Application for Licence Amendment

Licence Number	L8904/2015/1
Licence Holder	Cleanaway Solid Waste Pty Ltd
ACN	120 175 635
File Number	DER2015/001648-1~27
Premises	Banksia Road Putrescible Landfill Banksia Road CROOKED BROOK WA 6236 Legal description – Part of Lot 2 on Deposited Plan 65861 As defined by the coordinates in Schedule 2
Date of Report	3 February 2025
Decision	Revised Licence granted

- The licence holder is proposing a licence amendment to update the freeboard requirement in titanium dioxide slurry cell 2 (TDS Cell 2), from a vertical freeboard to a “volumetric freeboard”. Specifically, the amendment is proposed to Specification (d) in Table 8 of Condition 11, which currently requires 1.8 m freeboard to be always maintained in TDS Cell 2.

Figure 3: Visual freeboard measurement location.

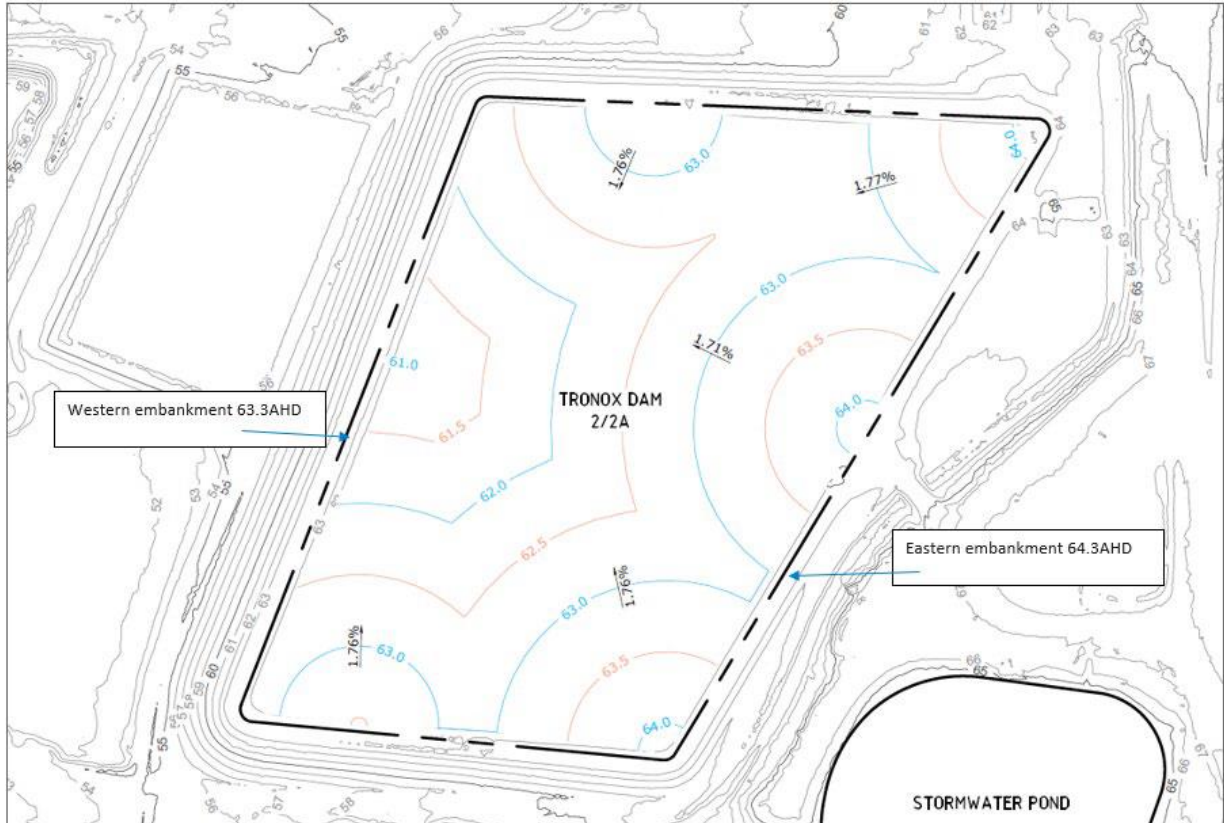
The Golder 2019 document calculates the design rainfall event in m³ as a volume, and then converts it to depth, based on the design beach profile. As shown on Figure 3, within that 1.8m freeboard, the actual storage capacity for water is relative to the beach slope, with a flatter beach slope resulting in a larger storage capacity and a steeper beach slope resulting in a smaller storage capacity.

The licence holder has advised that the beach slope in TDS Cell 2 is highly variable and so, to maintain the actual storage capacity, is requesting this stipulated volume applied to the licence as a more accurate way to measure available contingency volume within the cell.

As such, the Delegated Officer has determined that the calculation and maintenance of a contingency volume within TDS Cell 2 will be permitted through this amendment application, contingent on the licence holder continuing to monitor a vertical freeboard in line with current licence conditions.

Figure 4: Conventional freeboard measurement method.

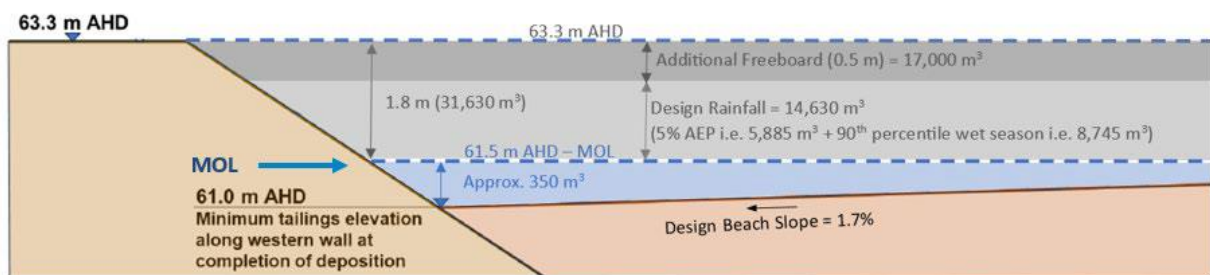
The below Diagram 2 details the MOL as a cross section at the position of measurement, per the basis of design (not to scale).

Where the MOL is exceeded, the EMP requires the following actions are undertaken:

1. Discontinue receiving inbound volume immediately,
2. Work with Customer to maximise outbound volume of leachate,
3. Pump volume from TDS cell into leachate cell to a maximum 1 m freeboard, and
4. Forecast weather dependant – assess taking volume offsite to water treatment facility.
